ISSUE	REASON	DATE
D1	FOR SSDA REVIEW	21.01.14
D2	CLIENT REVIEW	13.05.14
D3	RESPONSE TO SUBMISSIONS REVIEW	16.05.14
D4	RESPONSE TO SUBMISSIONS	21.05.14

PROJECT
1260 CENTRAL PARK 8
DRAWN
AC
APP'D
WS

DWG TITLE
LEVEL 9 FLOOR PLAN
DWG NO
DA:108
REV
D4

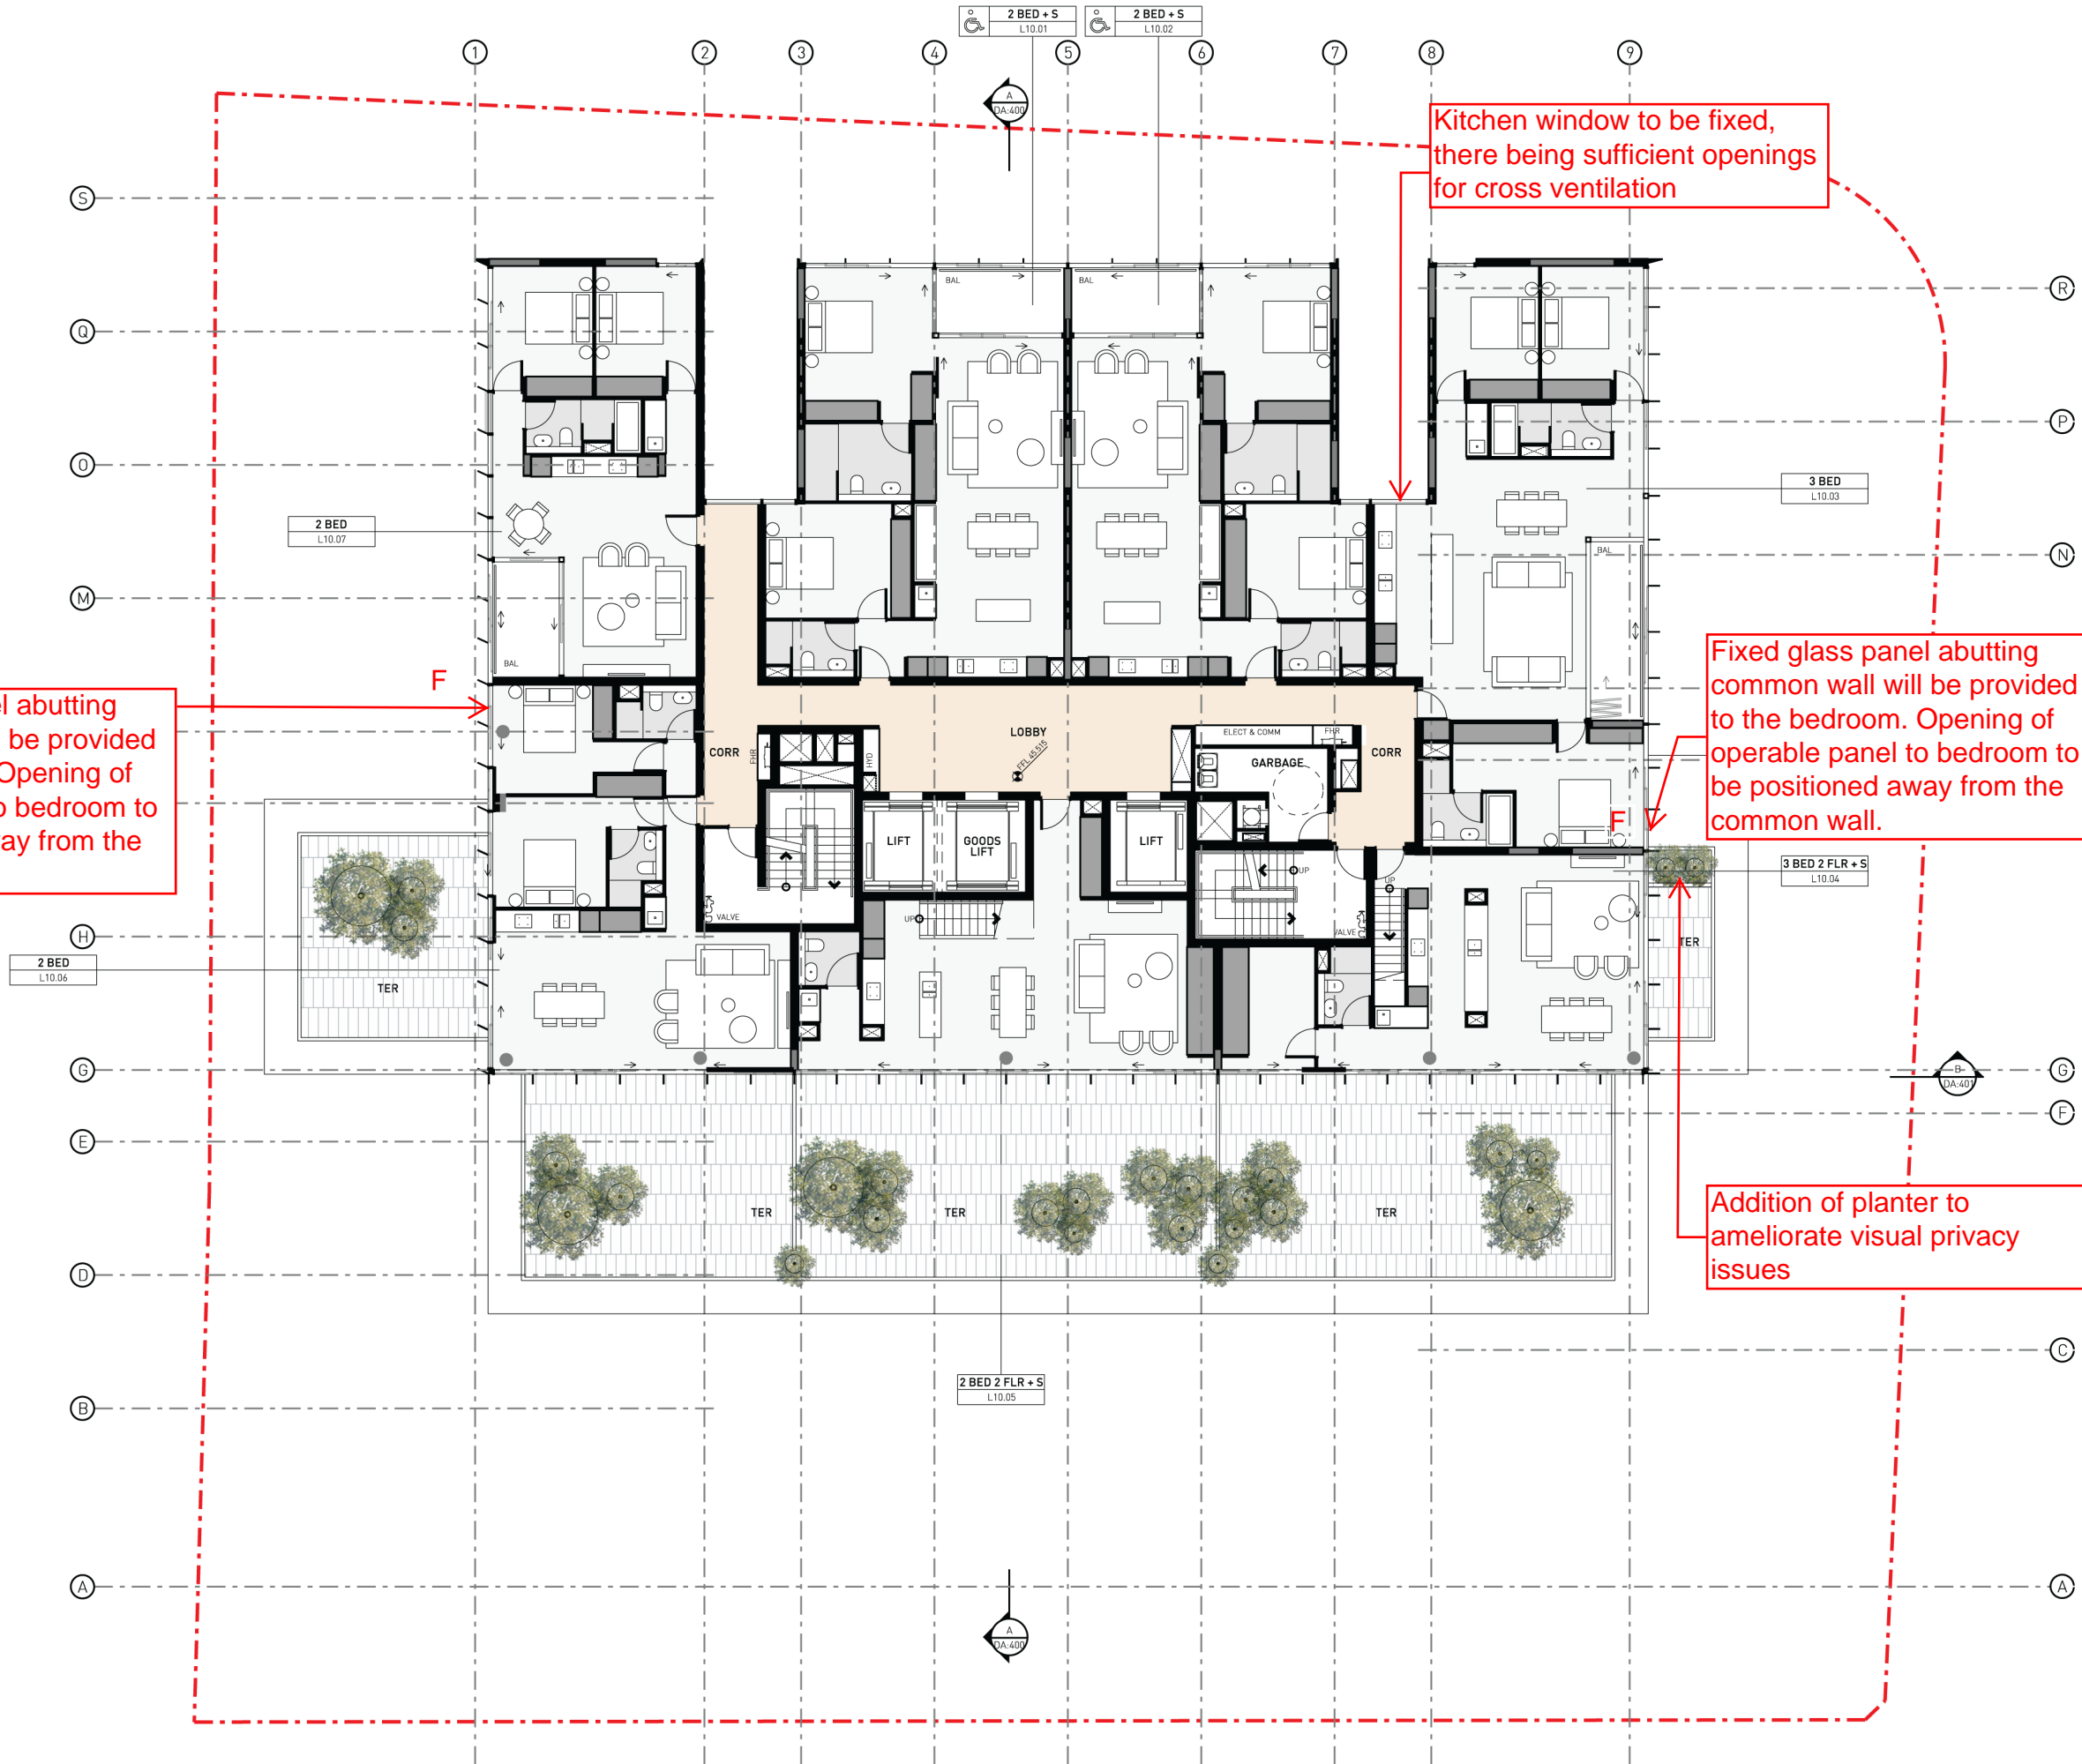
Fixed glass panel abutting common wall will be provided to the bedroom. Opening of operable panel to bedroom to be positioned away from the common wall.

Kitchen window to be fixed, there being sufficient openings for cross ventilation

Fixed glass panel abutting common wall will be provided to the bedroom. Opening of operable panel to bedroom to be positioned away from the common wall.

Addition of planter to ameliorate visual privacy issues
